Title - Sujet South Substation Switchgear Replace	
Solicitation No. - N° de l'invitation EZ108-162126/A	Amendment No. - N° modif. 005
Client Reference No. - N° de référence du client	Date 2016-03-14
GETS Reference No. - N° de référence de SEAG PW-\$PWY-026-7753	
File No. - N° de dossier PWY-5-38400 (026)	CCC No./N° CCC - FMS No./N° VME
Solicitation Closes - L'invitation prend fin at - à 02:00 PM on - le 2016-03-29	Time Zone Fuseau horaire Pacific Daylight Saving Time PDT
F.O.B. - F.A.B. Plant-Usine: <input type="checkbox"/> Destination: <input checked="" type="checkbox"/> Other-Autre: <input type="checkbox"/>	
Address Enquiries to: - Adresser toutes questions à: Liu (PWY), Patty	Buyer Id - Id de l'acheteur pwy026
Telephone No. - N° de téléphone (604) 775-6227 ()	FAX No. - N° de FAX (604) 775-6633
Destination - of Goods, Services, and Construction: Destination - des biens, services et construction: PWGSC - Esquimalt Graving Dock - Victoria, BC

AMENDMENT 005

**PWGSC EGD SOUTH SUBSTATION
SWITCHGEAR REPLACEMENT (SSSR)
MECHANICAL ADDENDUM NO. M2**

Project No./N° du projet: 825 ADMIRALS ROAD, VICTORIA, B.C.
ESQUIMALT GRAVING DOCK
ELECTRICAL SAFETY UPGRADE
SOUTH SUBSTATION
SWITCHGEAR
R

- .1 See attached revised sheet 5100 Showing tug wharf location.
- .22 The switch symbols on 5109 indicate dual switches but no switching designations are indicated on the fixtures. Please confirm if dual switching is desired.**

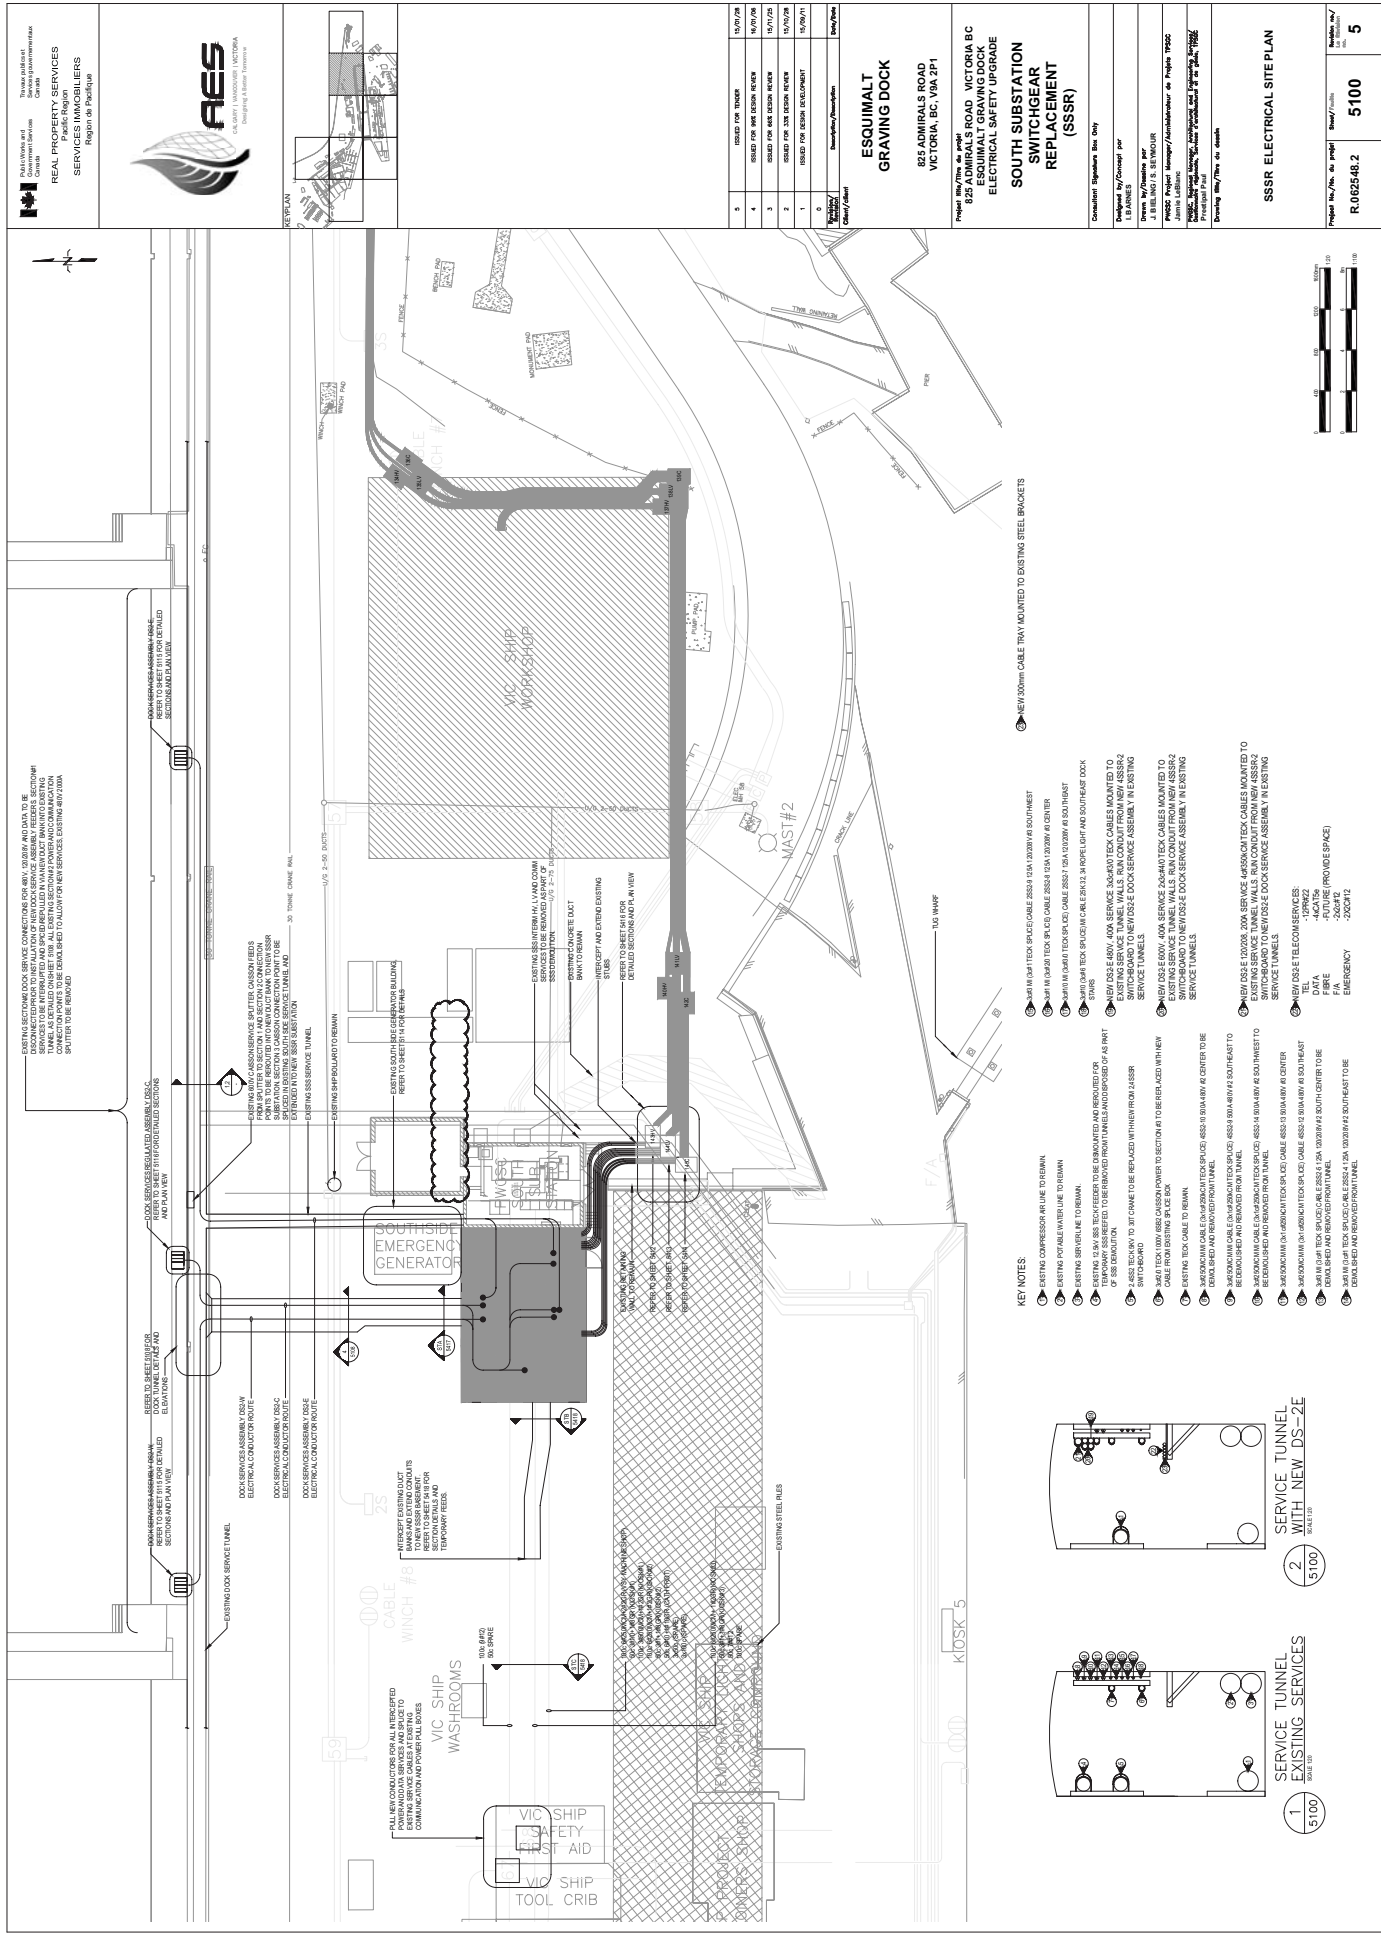
- .1 Use values given on sheet 5905 for take offs.
- .21 Tug wharf is shown on 5905 requiring cabling but I am unable to find a site plan that locates the wharf. Please provide a plan showing the routing that can be scaled.**

- .1 Section STC indicates all services running in existing duct bank, Notes on sheet 5100 are missing 50pr#22 tel and 12pr#22, 1 fibre fire alarm circuits. Drawing 5100 - Add 2x50mm to conduit and conductor counts "50pr#22 tel and 12pr#22, 1 fibre fire alarm circuits".
